D5充电桩主板

项目代号：PJ0050_CT04

版本：A01

TITLE: PJ0050_CT04_SCH-A00

备用电池充电

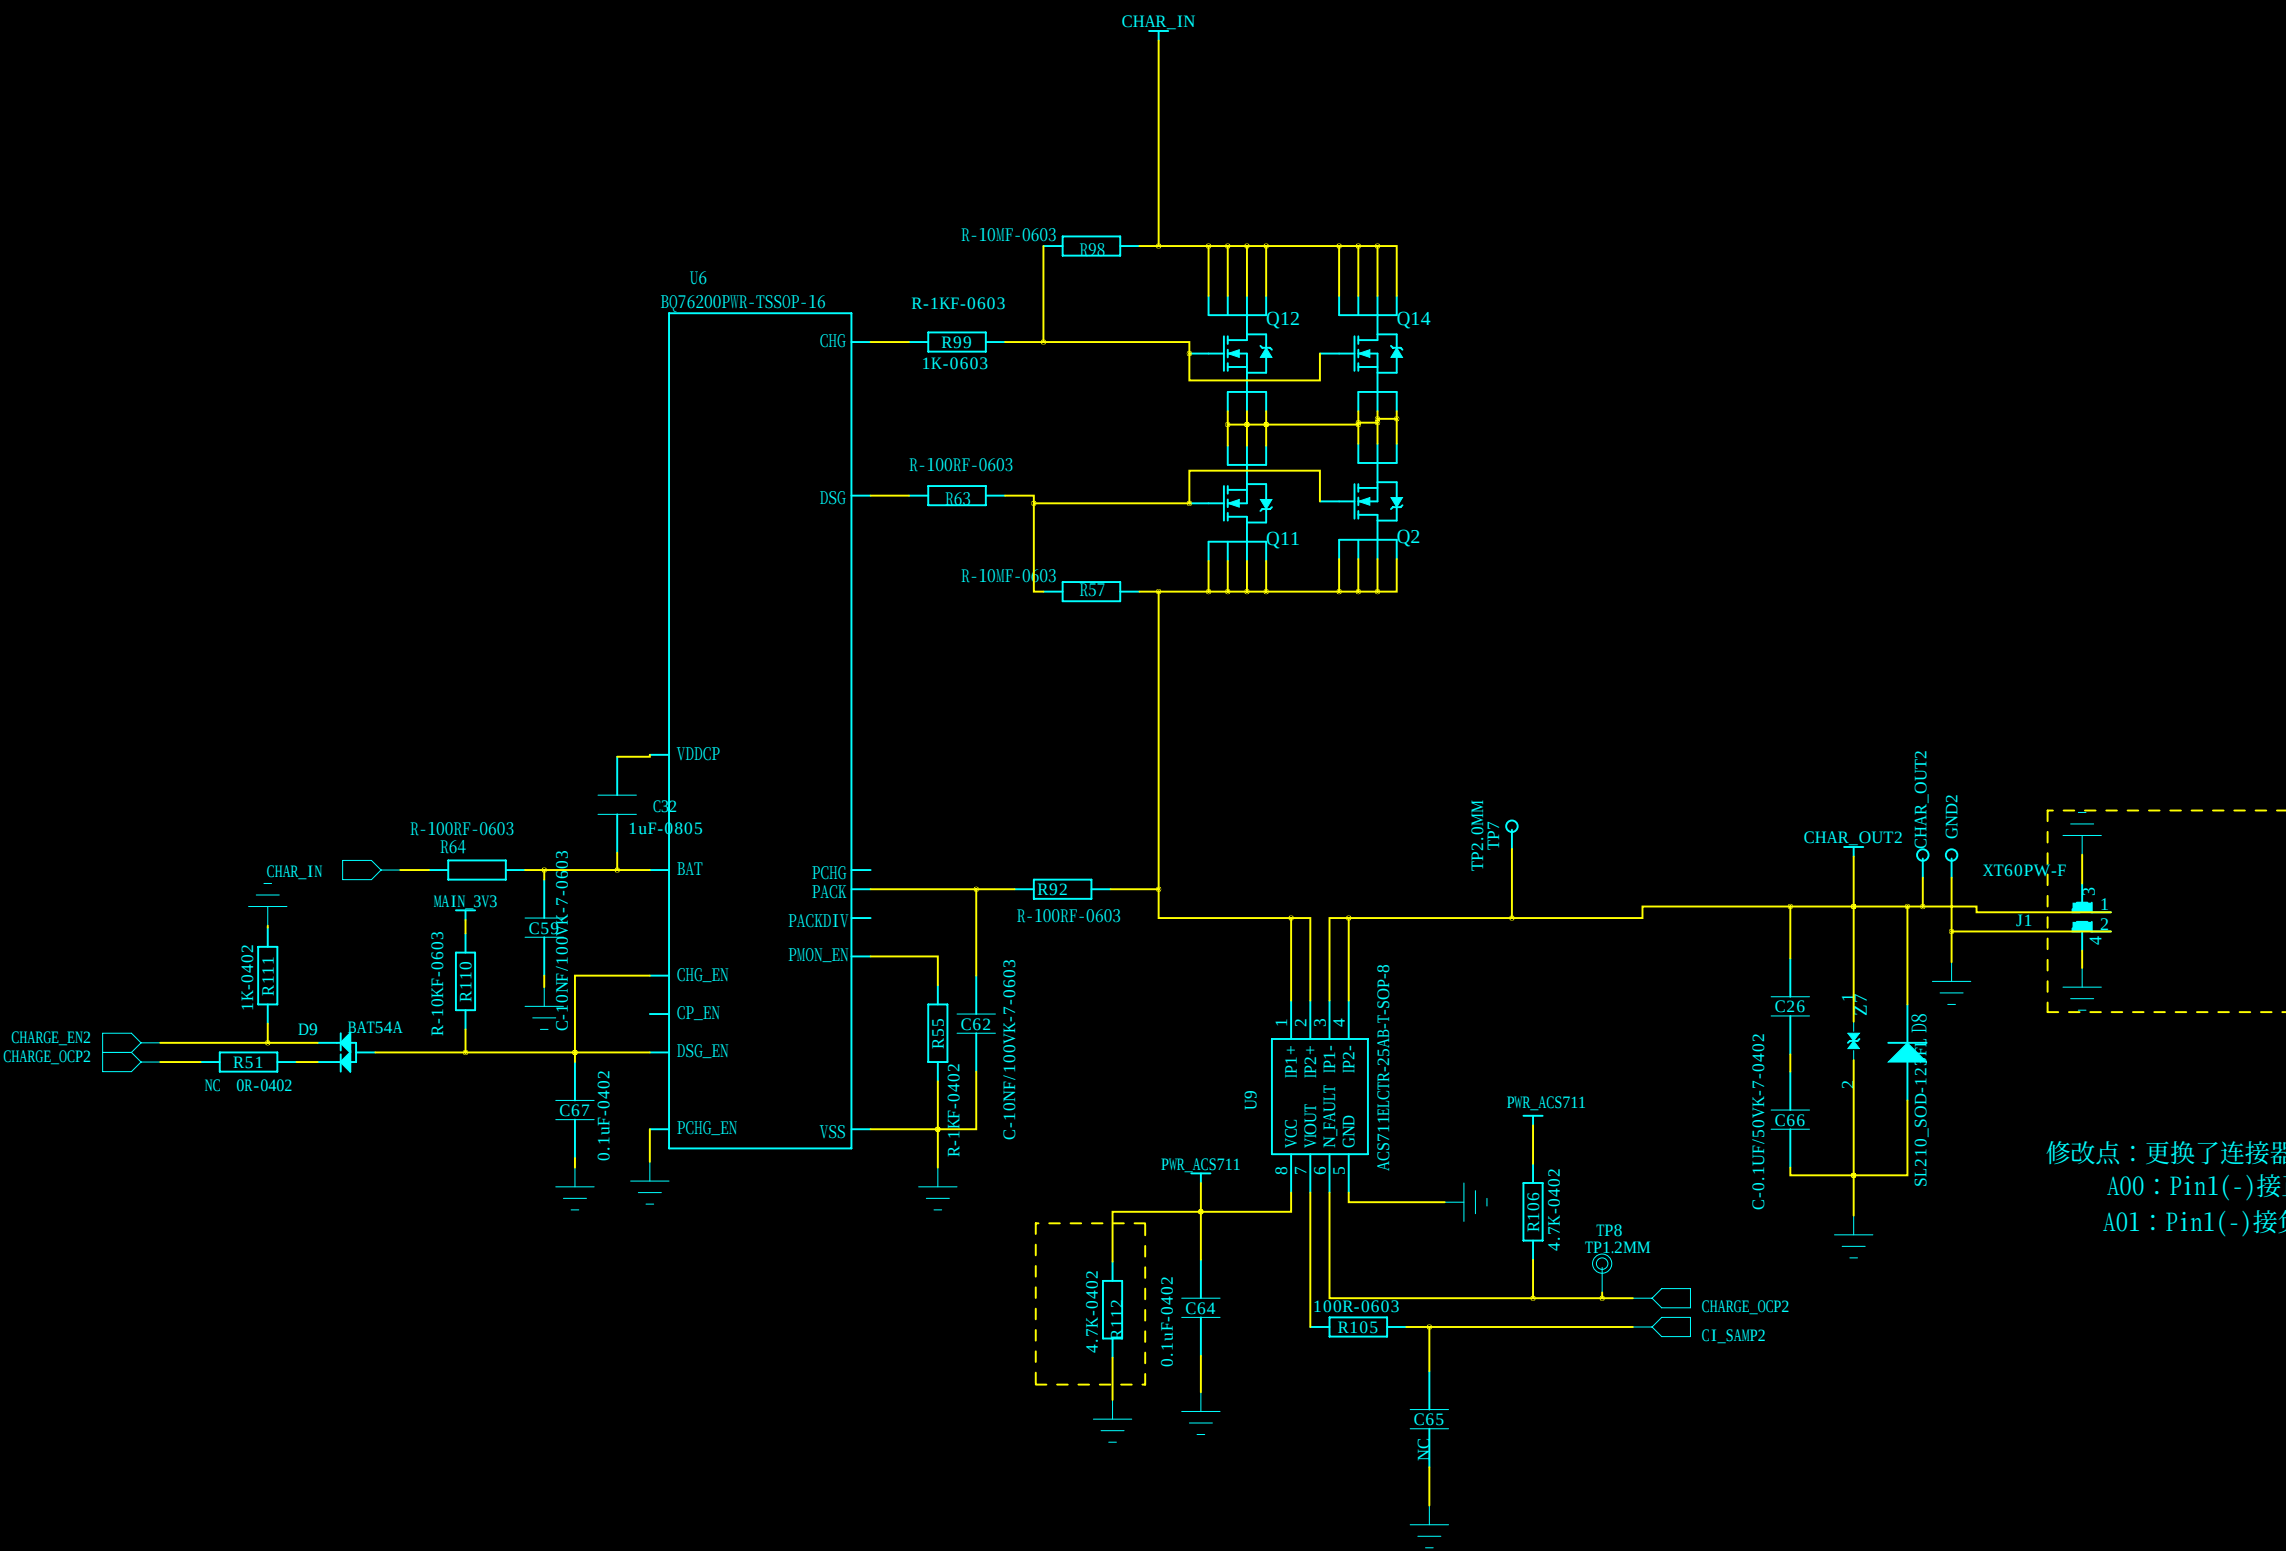
修改点：更换了连接器引脚，线缆对应修改。
A00：Pin1(-)接正；Pin2(+)接负
A01：Pin1(-)接负；Pin2(+)接正

D5充电

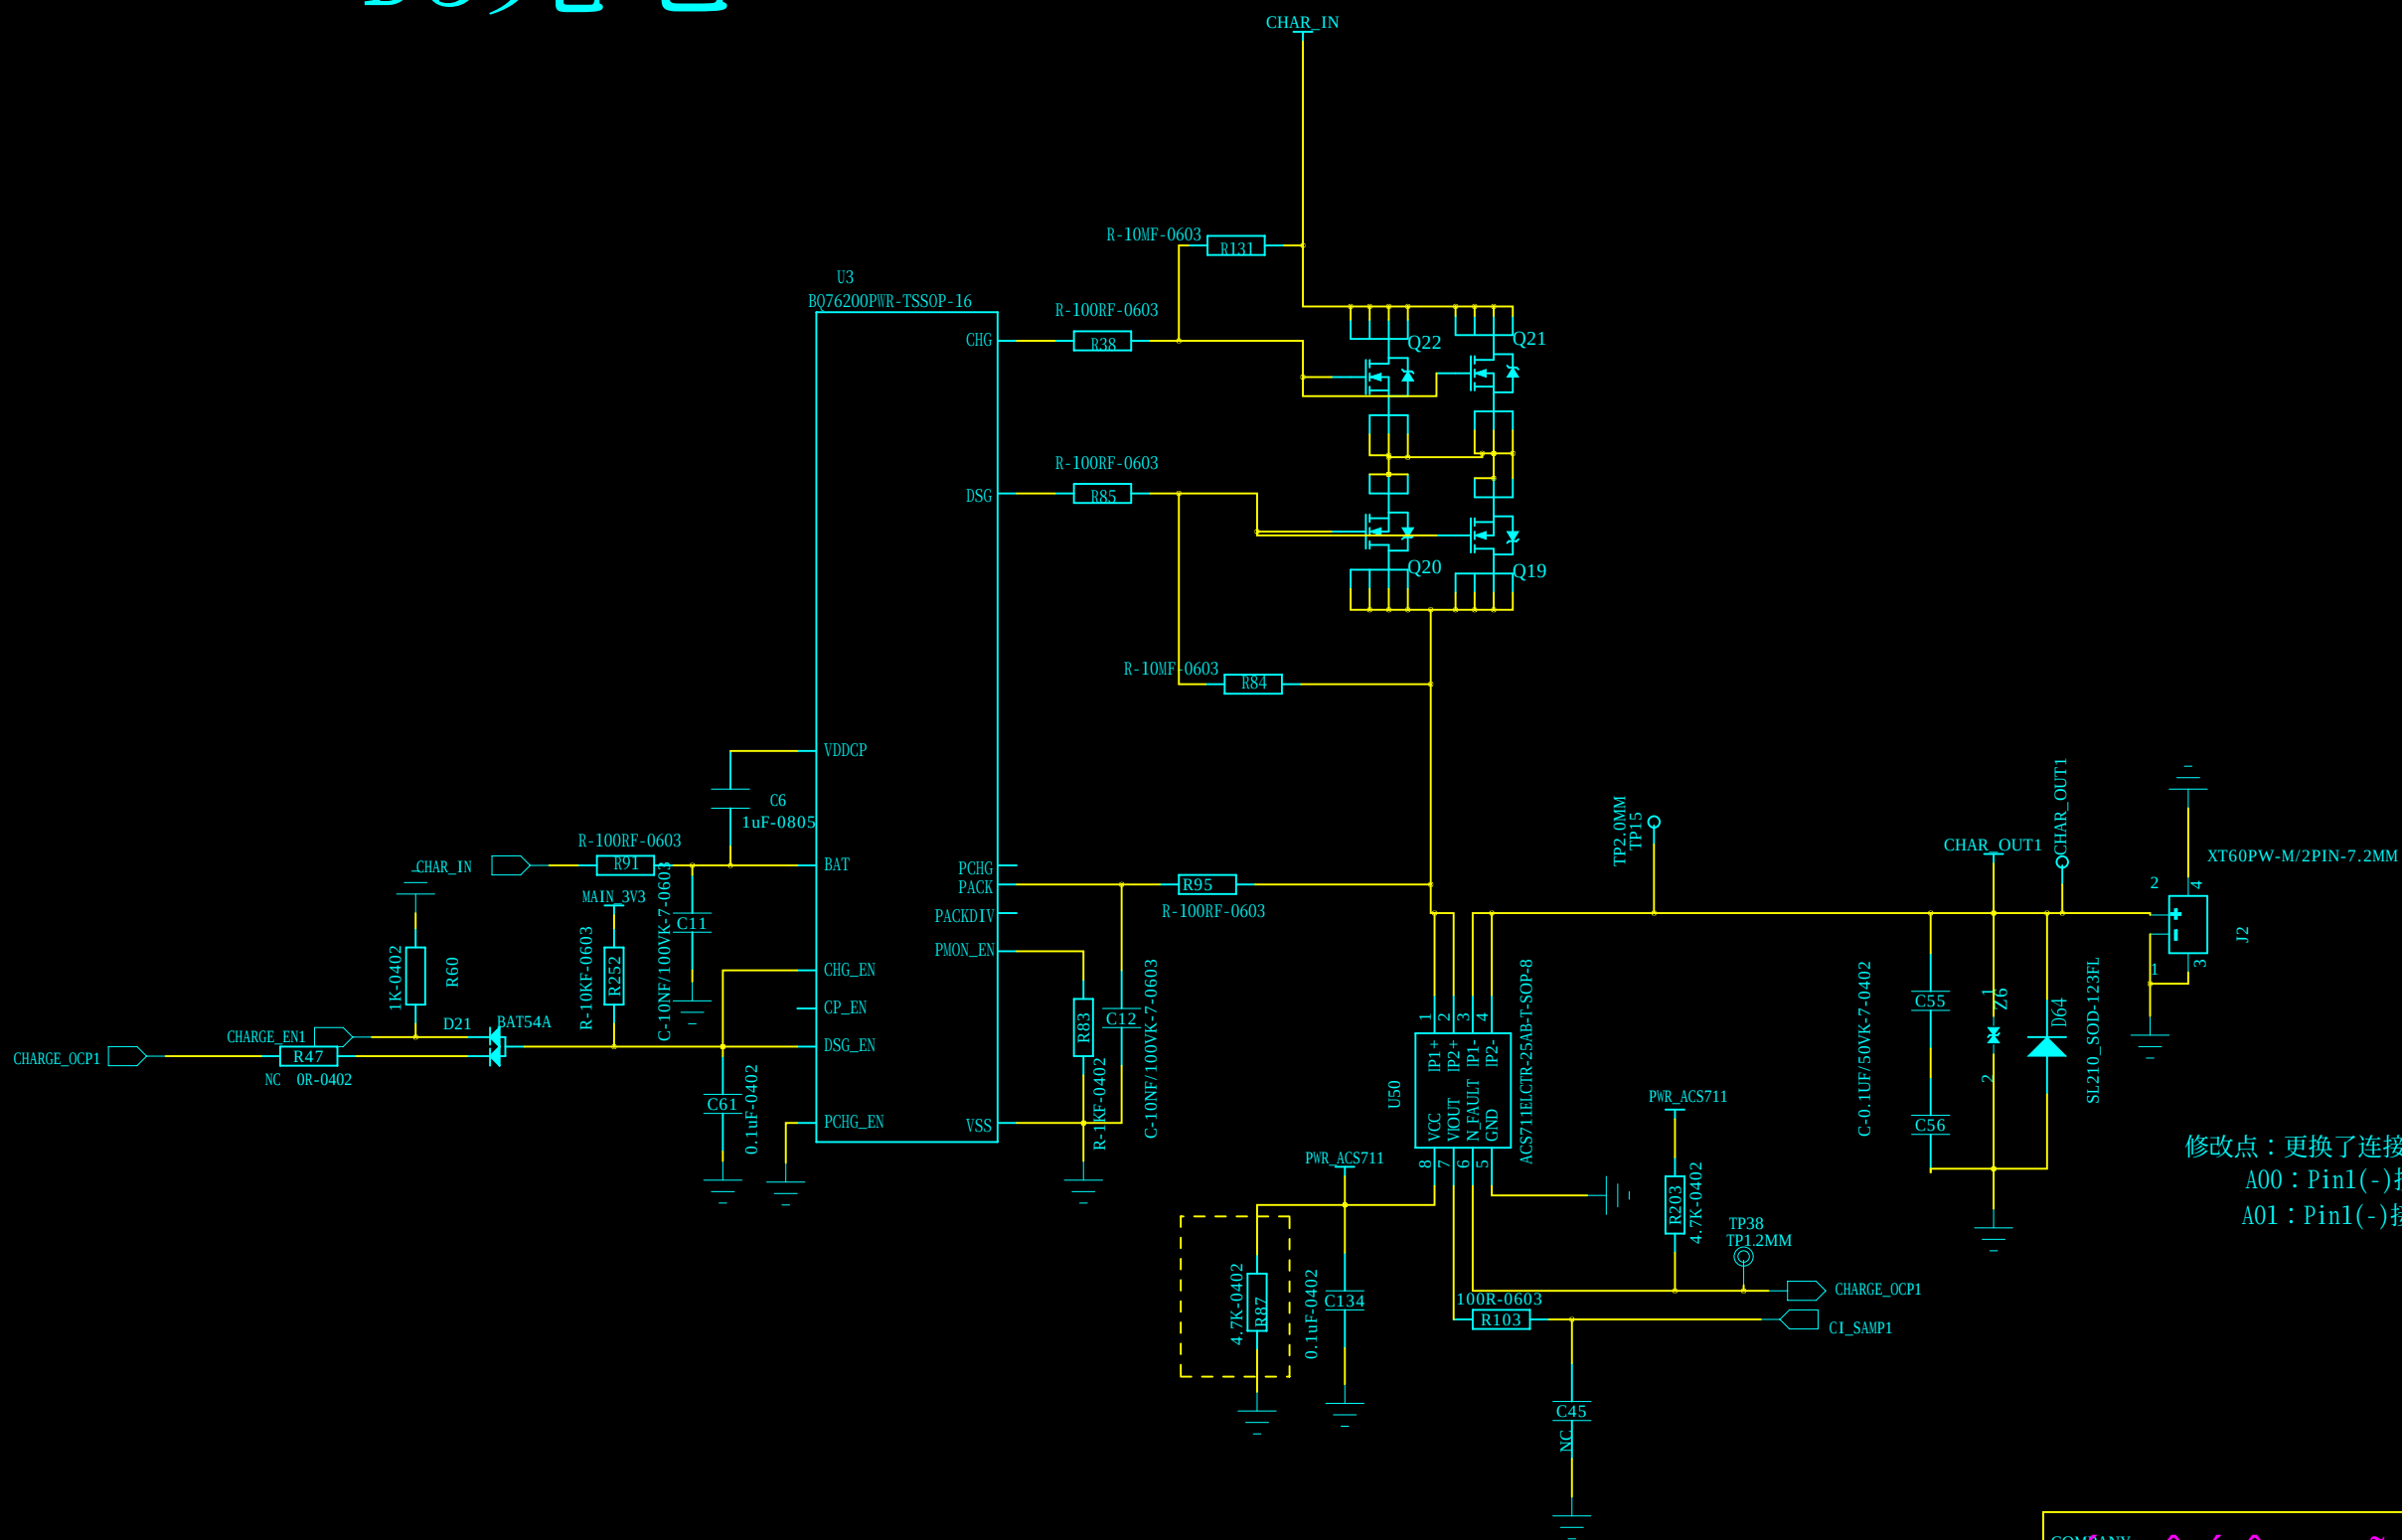
修改点：更换了连接器引脚，线缆对应修改。
A00：Pin1(-)接正；Pin2(+)接负
A01：Pin1(-)接负；Pin2(+)接正

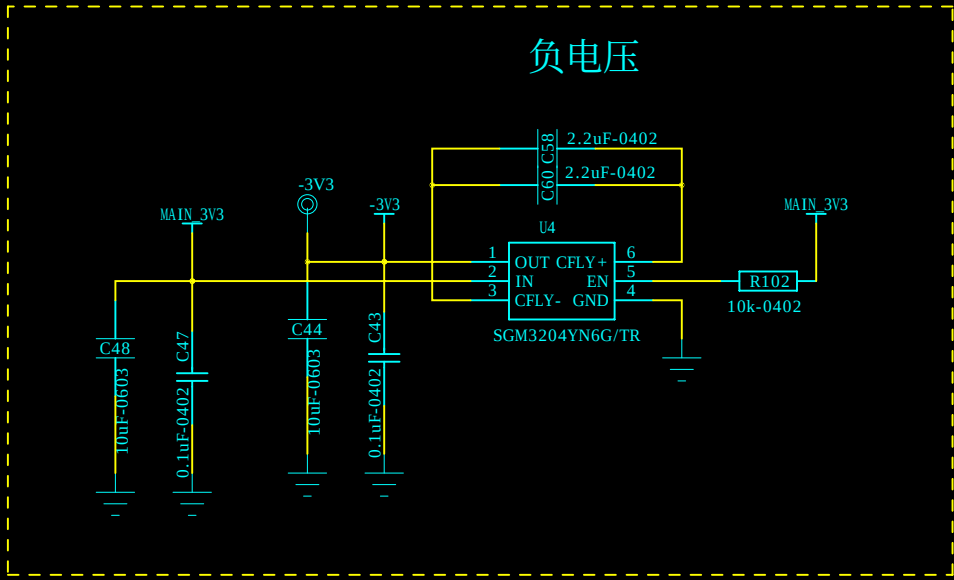
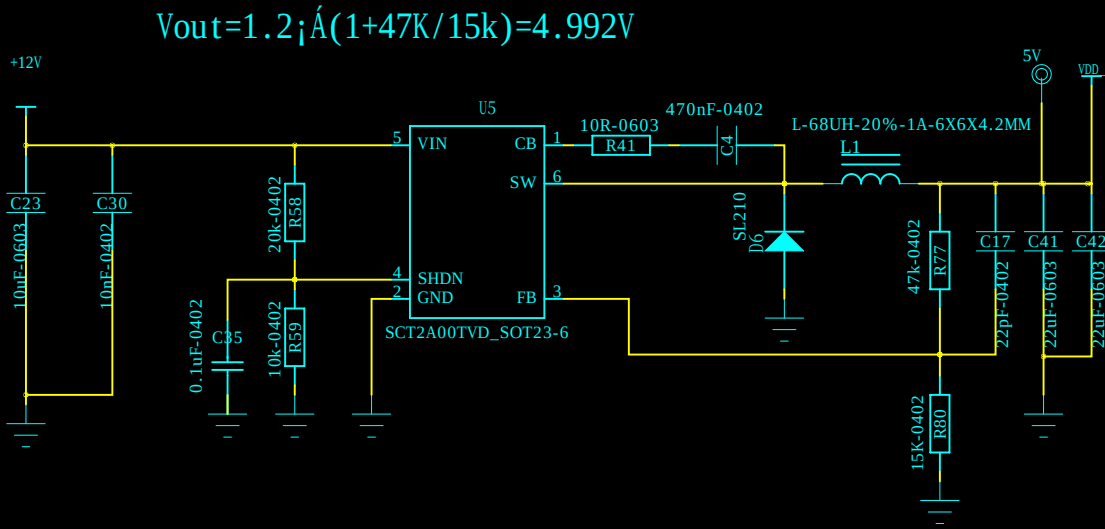
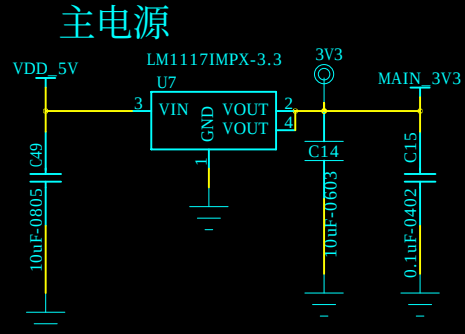
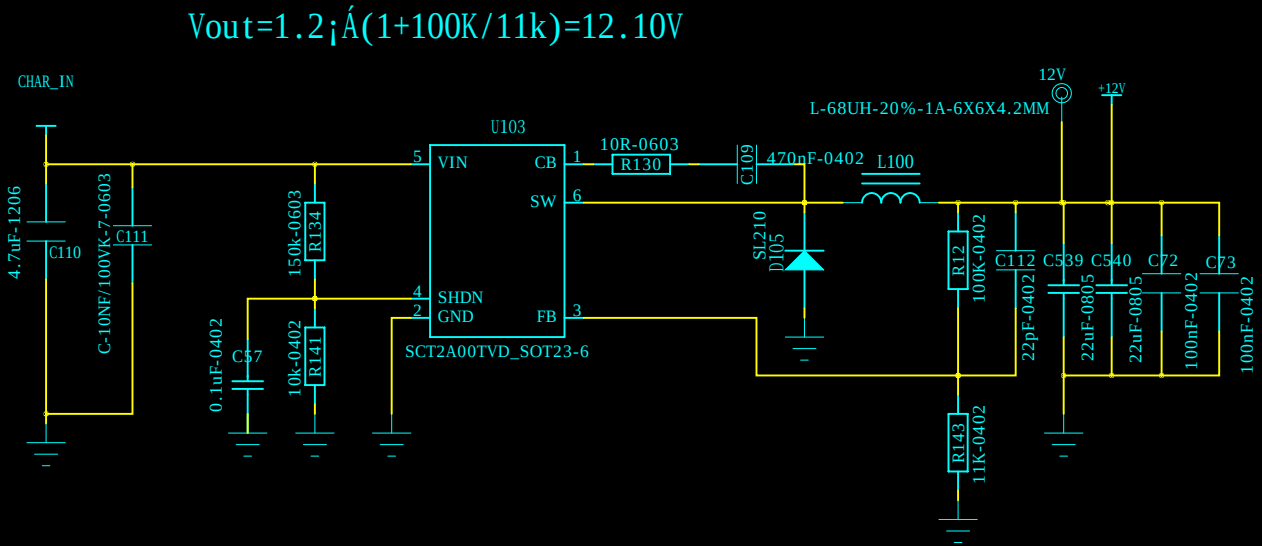
修改点：
A00：无负电压电路；
A01：新增负电压电路；
